**WHITE LAKE TOWNSHIP
INTER-OFFICE MEMORANDUM
COMMUNITY DEVELOPMENT DEPARTMENT**

**SUBJECT: Panera
Preliminary site plan approval**
Property described as parcel number 12-20-276-035, located north of Highland Road (M-59), west of Bogie Lake Road, southeast of Meijer consisting of approximately 1.63 acres.

RE: Panera Bread and Retail Development- Preliminary Site Plan Review – 3rd Review

RE: Panera Bread
Preliminary Site Plan – Review #3

DRAWING: **C-3**

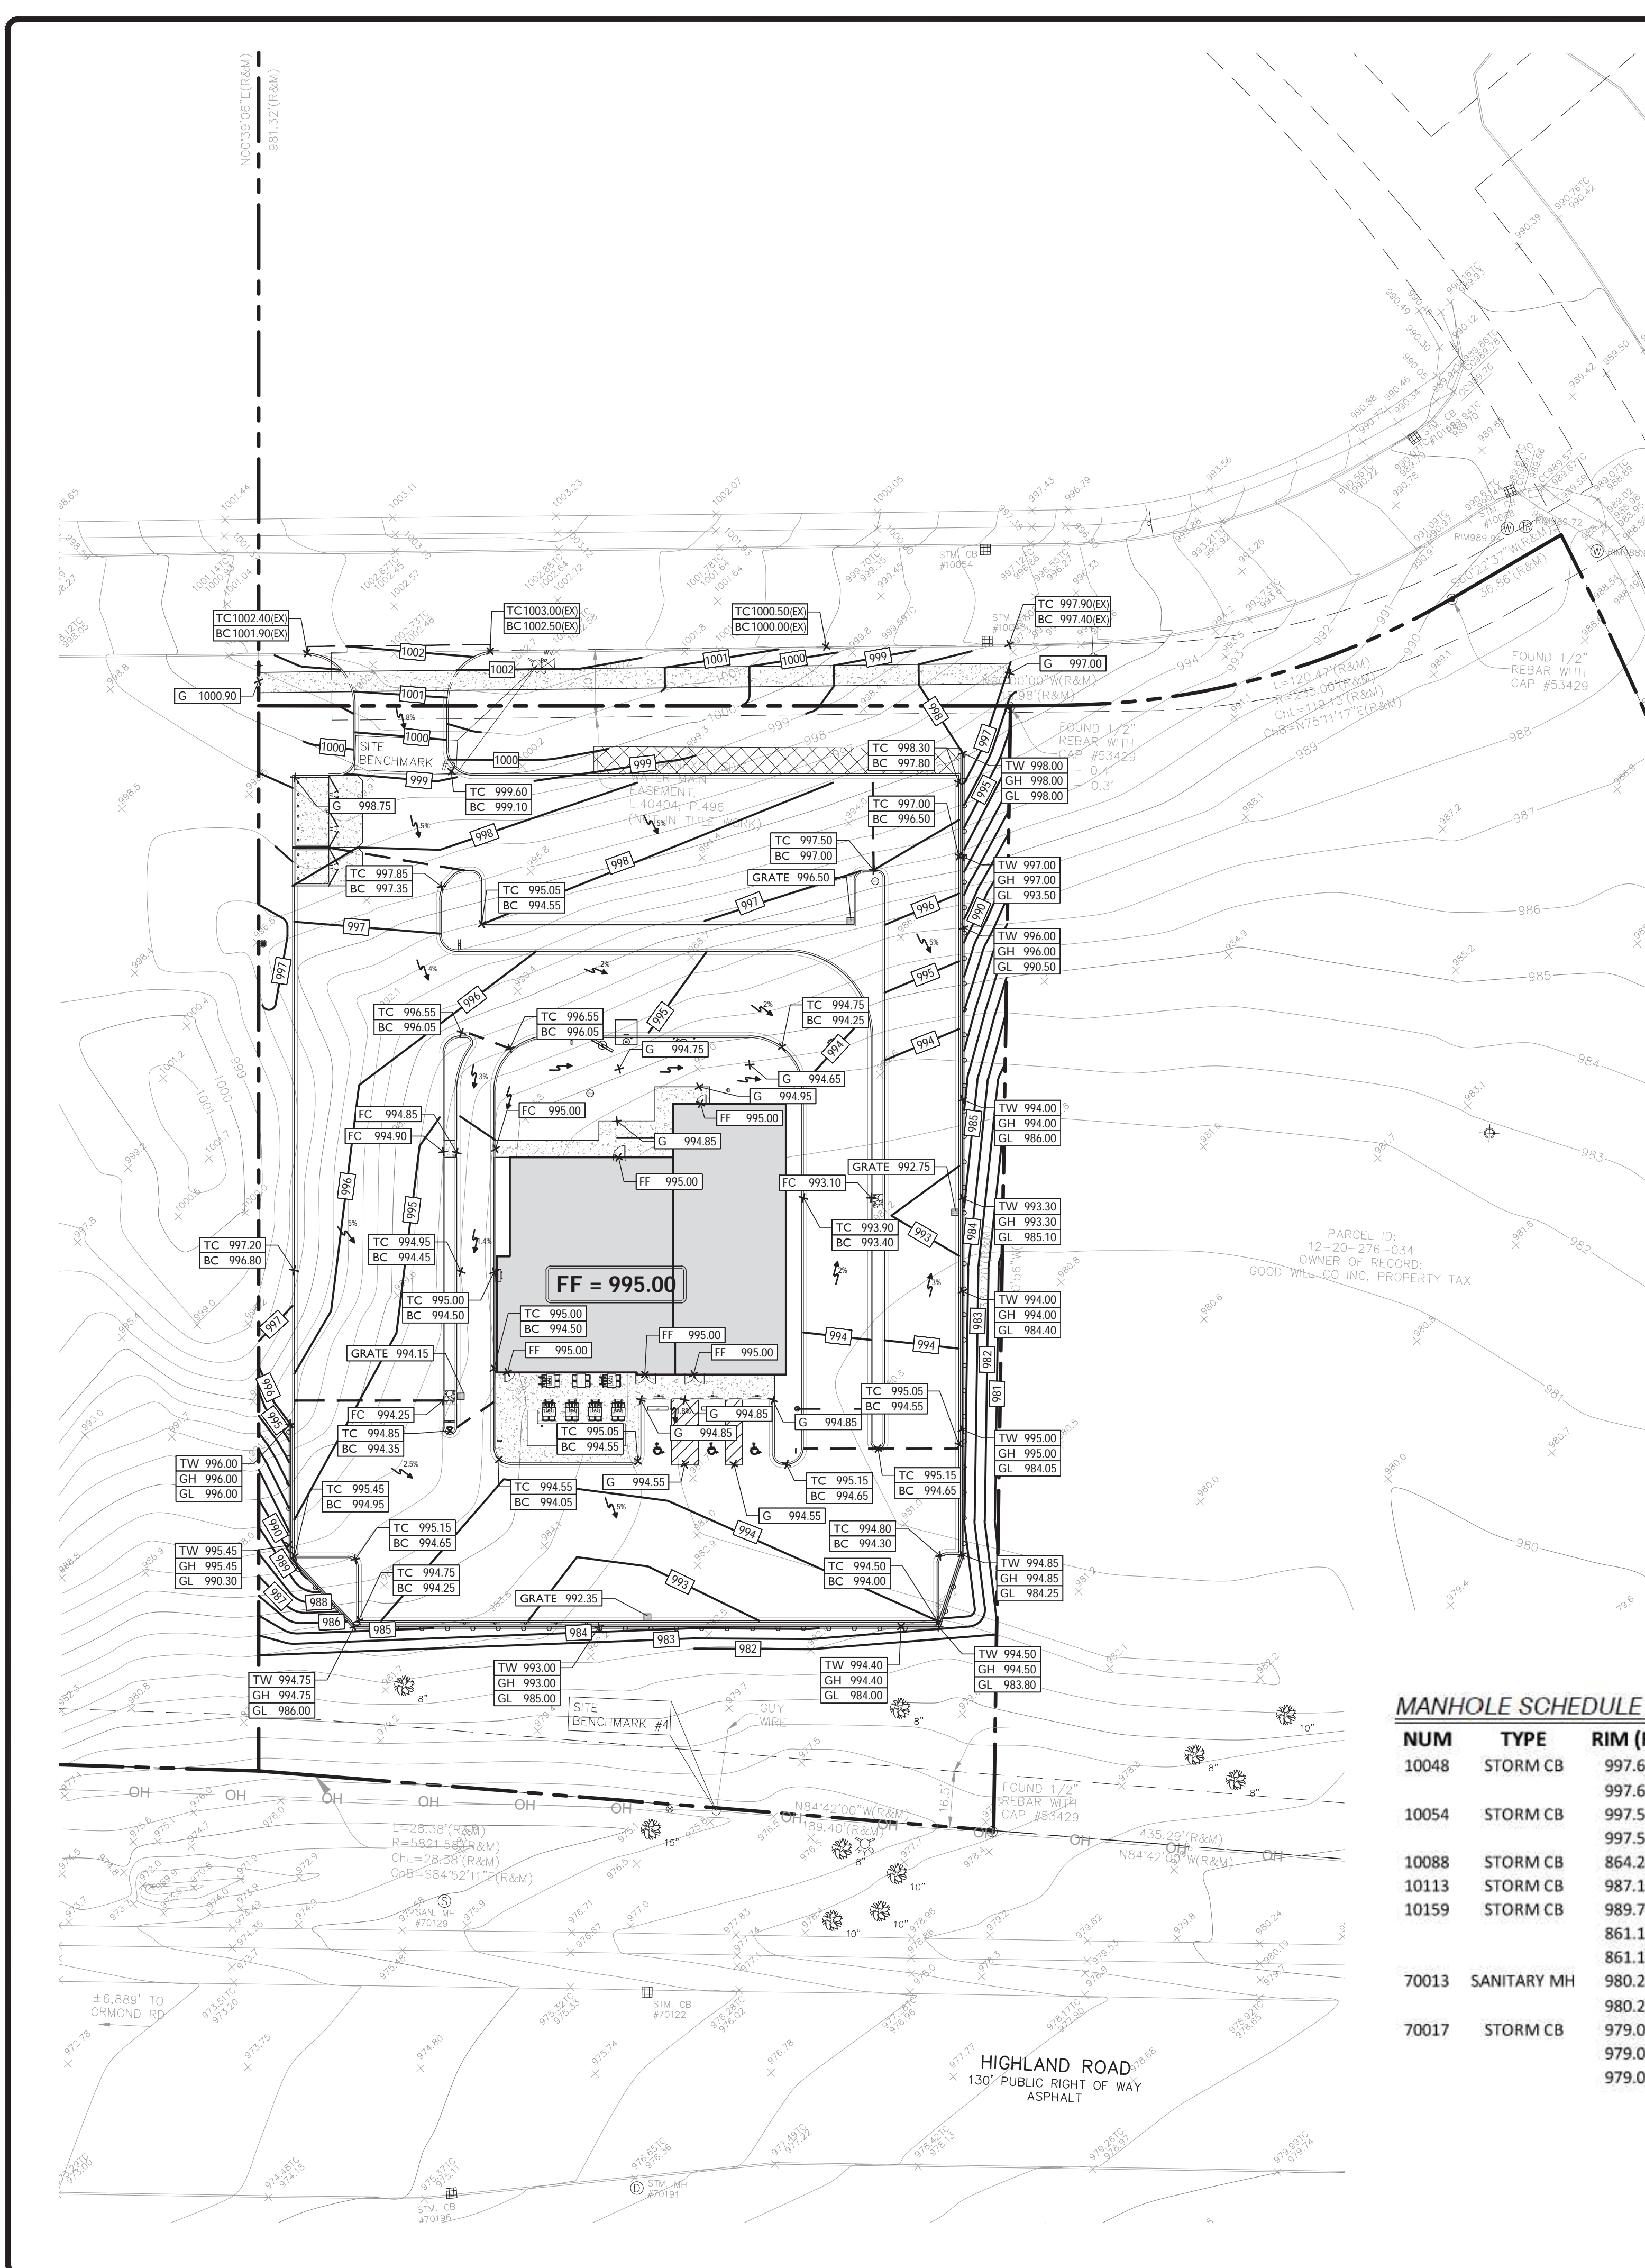
- c) *The parking layout does not lend itself to safe ingress and egress of pedestrians to the restaurant and/or retail space; most pedestrians will be required to cross the drive thru lanes to gain access to the restaurant and/or retail. Comment partially addressed. Please provide a note on Sheet C-3 that a 'Yield to Pedestrians in Cross Walk' sign shall be provided at the southernmost crosswalk. **Comment addressed. A note to provide a sign has been added to Sheet C-3.***

The zoning ordinance requires a minimum eight-foot-wide sidewalk along the Highland Road property frontage. Sidewalk along the aforementioned frontage was constructed by Meijer at the time of the initial development **(the width of the existing sidewalk shall be dimensioned on the site plan). (Comment addressed. Existing sidewalk width (six feet) has been dimensioned on the plans).** **The Applicant shall be required to repair/replace any broken sections of concrete within the frontage sidewalk adjacent to the site along Highland Road, as determined by the Township Engineering Consultant. This shall be noted on Sheet C-3. (Comment addressed. A note has been added as required).**

A snow storage plan was not provided. Information on method of snow storage shall be provided (denote snow storage areas on Sheet C-3). (Comment addressed. A snow storage area has been indicated on Sheet C-3). Winter maintenance of parking lot landscape islands shall be required where heavy applications of salt and de-icing products occur through the use of salt tarps which minimize soil absorption and ultimately reduce plant disorders. (Comment addressed. A maintenance note has been added to Sheet C-8).

General Note 14 on Sheet C-3 states all trash pick-up would occur off-hours as to not conflict with customer traffic flow.

An outdoor patio is proposed at the southwest corner of the building. **Label the size (square footage) of the patio, as well as the proposed number of tables and chairs, on Sheet C-3. (Comment outstanding. The square footage and number of seats have been added to the patio callout on Sheet C-3, but the proposed number of tables remains unidentified. Additionally, Sheet G131 of the architectural plans identifies the patio area as 813 square feet in size. Revise for consistency). (Comment addressed. The patio has been reduced to 394 square feet and a maximum of 28 seats. Tables have been shown on Sheet C-3. Sheet G131 has been updated accordingly).**

DRAWING: **C-4**

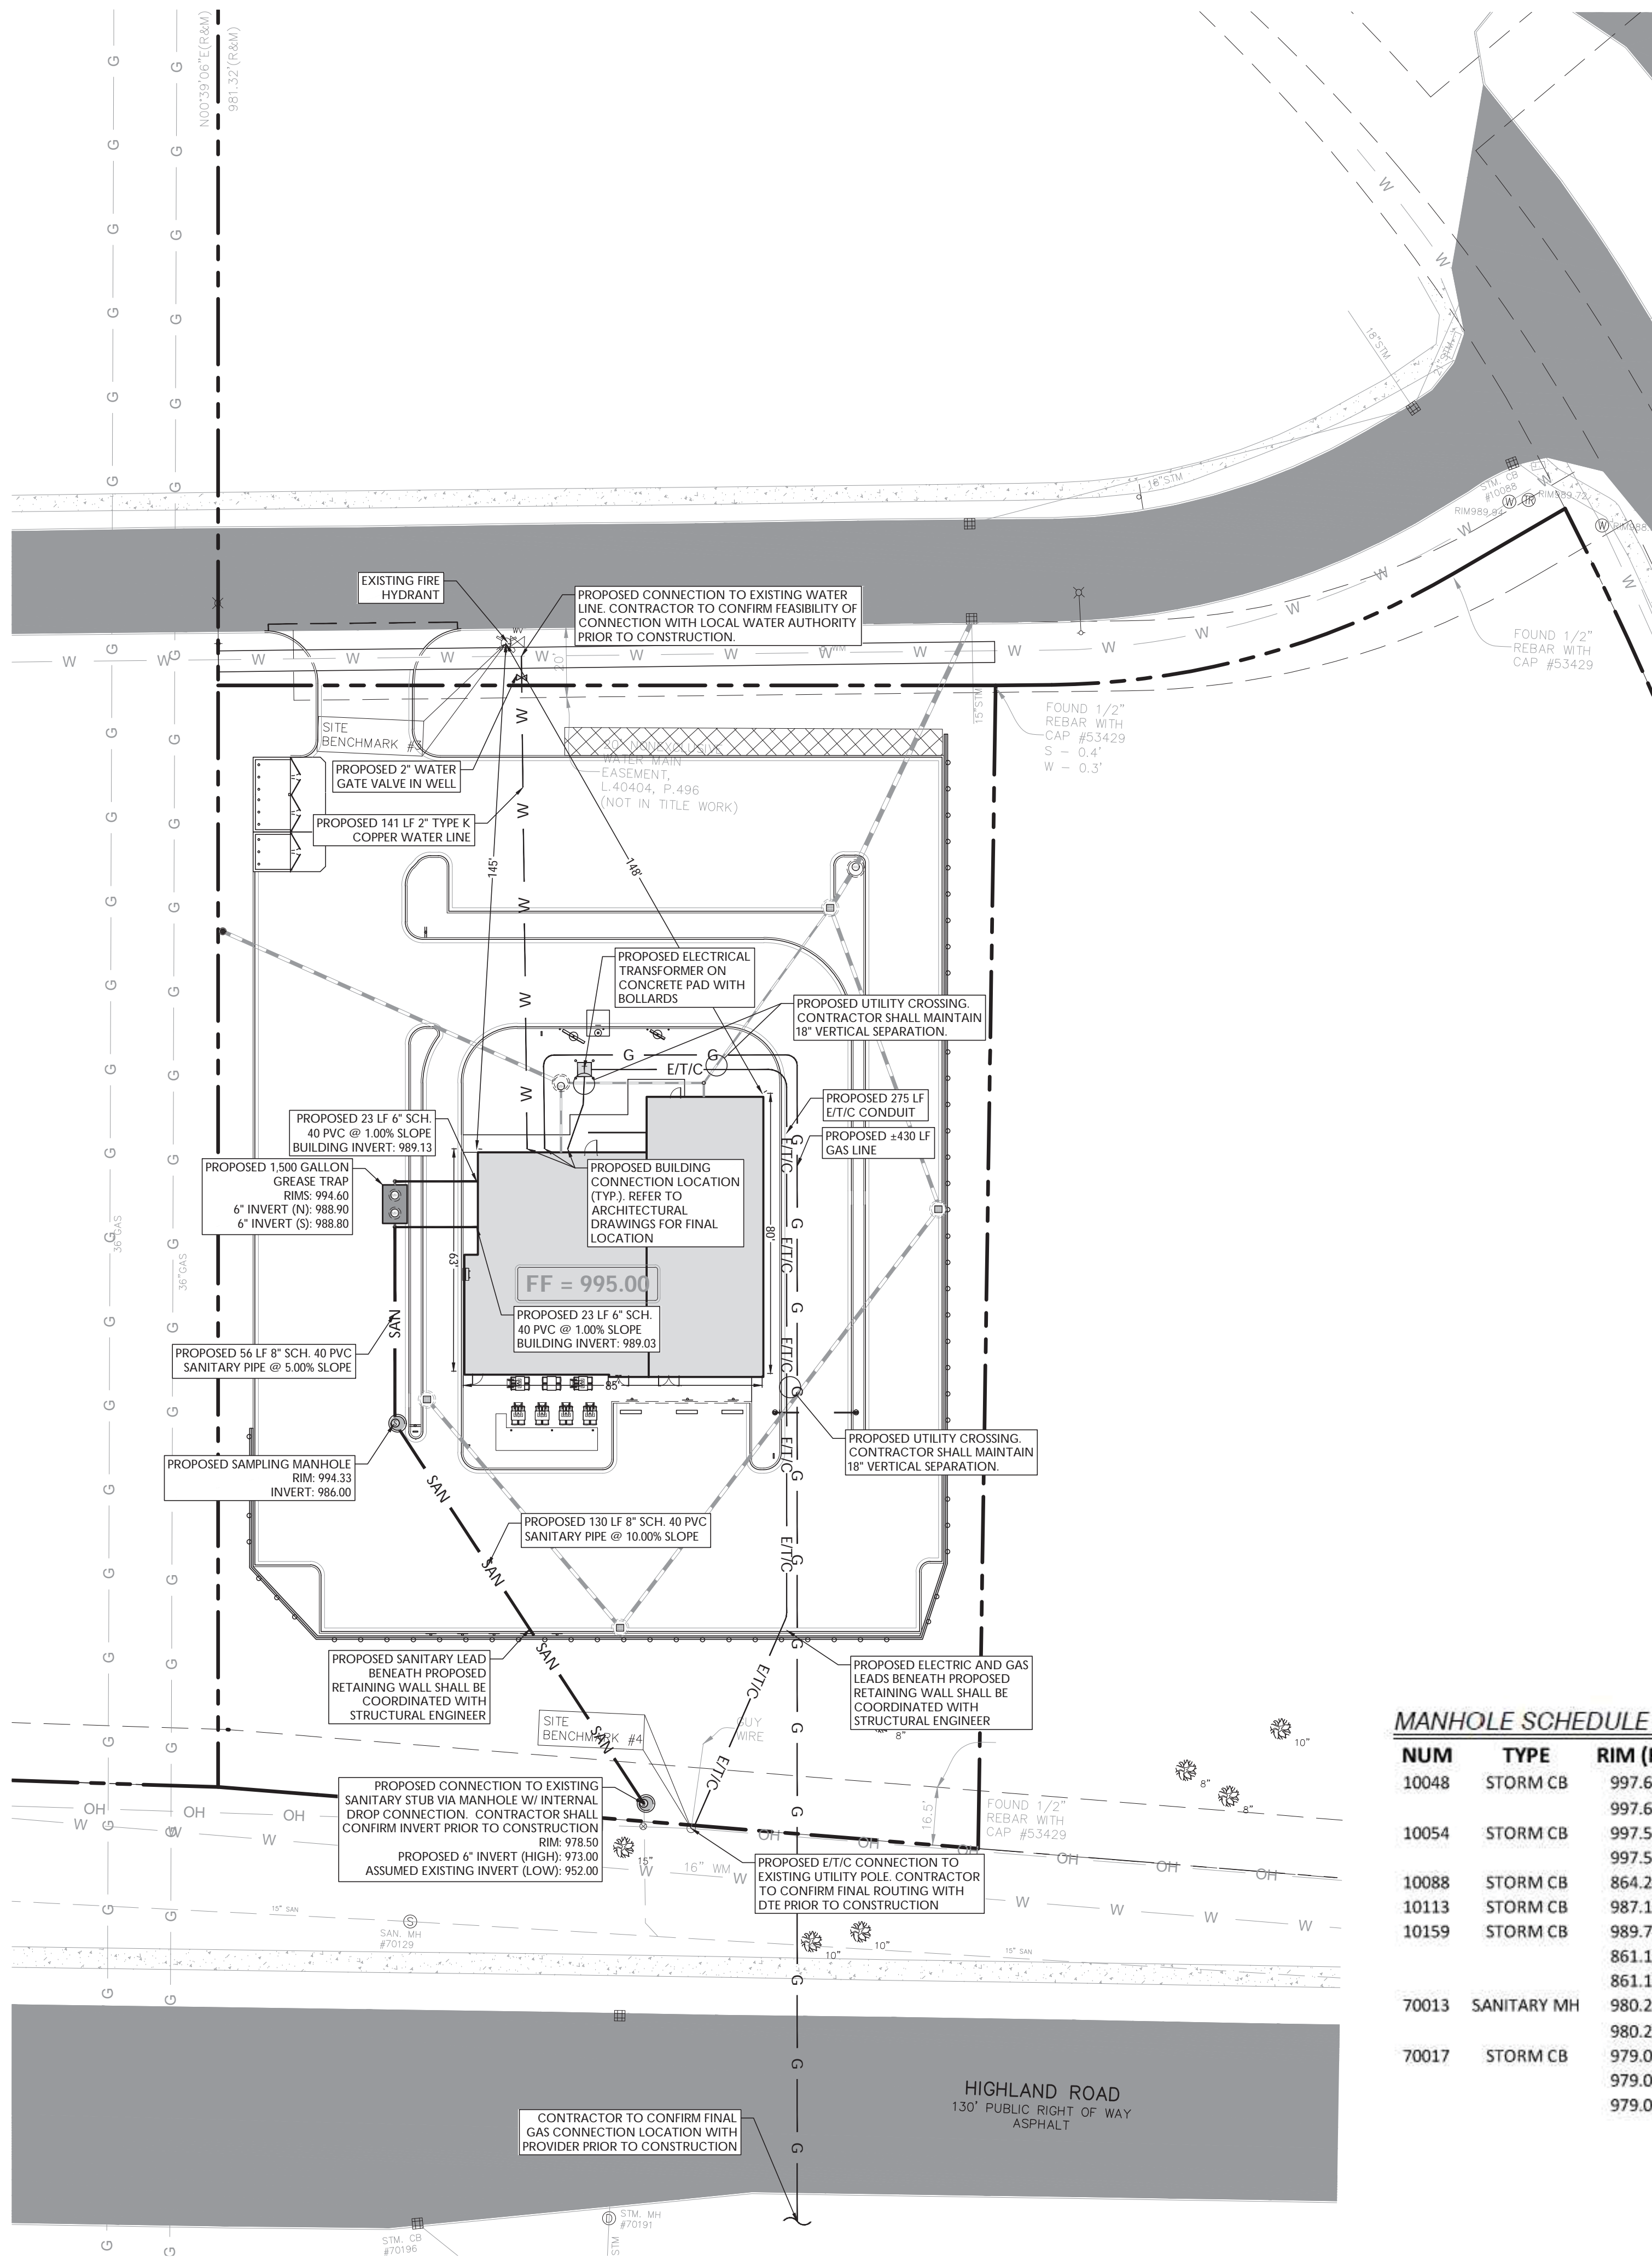
- j) *Preliminary grading of the site has been proposed and demonstrates general drainage patterns; we note that the proposed 997 contour near the northwest corner of the site will result in ponding of water with no positive outlet. We further note that the wall grades on the south of the property are off in elevation with a top of wall grade 40 feet below the bottom. Please note that retaining walls over 30" in height will require a decorative railing. Please revise. Comment partially addressed. A yard inlet has been provided at the low point. In addition, proposed wall height elevations have now been adjusted. Please add a note regarding the requirement for decorative fencing at the top of the wall. **A note regarding the installation of a guide rail at the top of the retaining wall has been added to Sheet C-3. A detail of the guide rail shall be required at the time of FEP submittal.***

SINGLE TRASH ENCLOSURE DETAIL

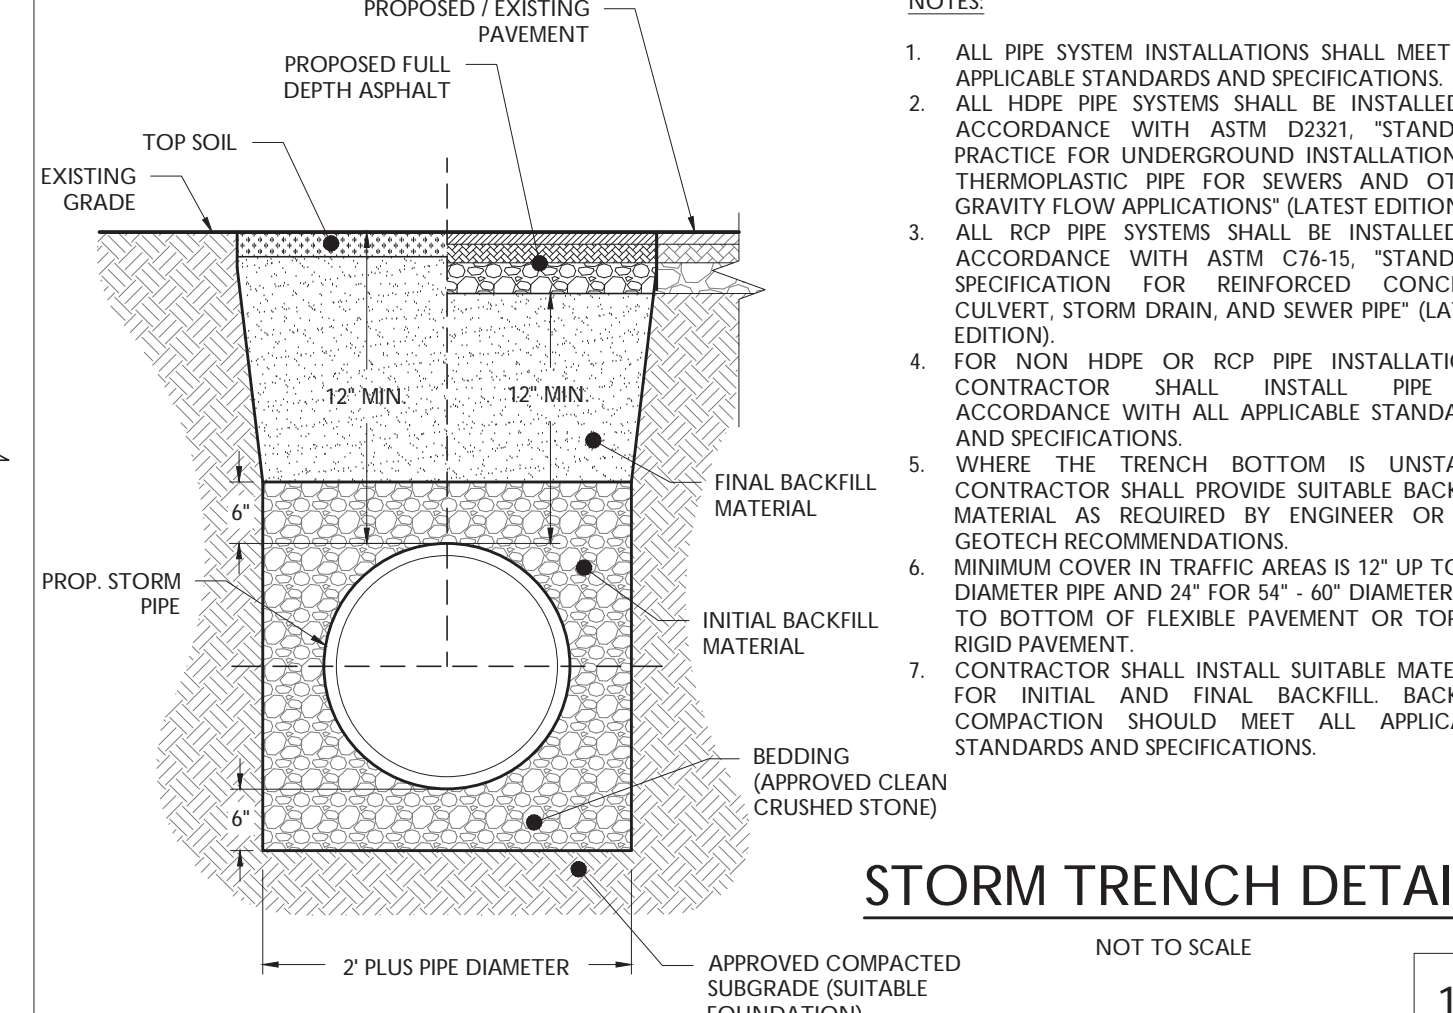
The trash enclosure detail on Sheet C-9 shall be revised to be consistent with Sheet C-3 which shows partitioning wall(s) separating the southerly third of the enclosure from the northerly two-thirds of the enclosure. Sheet C-3 shall include labels to note the type of bins to be placed in each portion of the enclosure. (Comment partially addressed. There are two separate trash enclosure details, a single and a double constructed side by side. The single enclosure detail has been added to the plans. However, four-inch bollards are proposed, and six-inch concrete-filled steel bollards are required – revise accordingly).
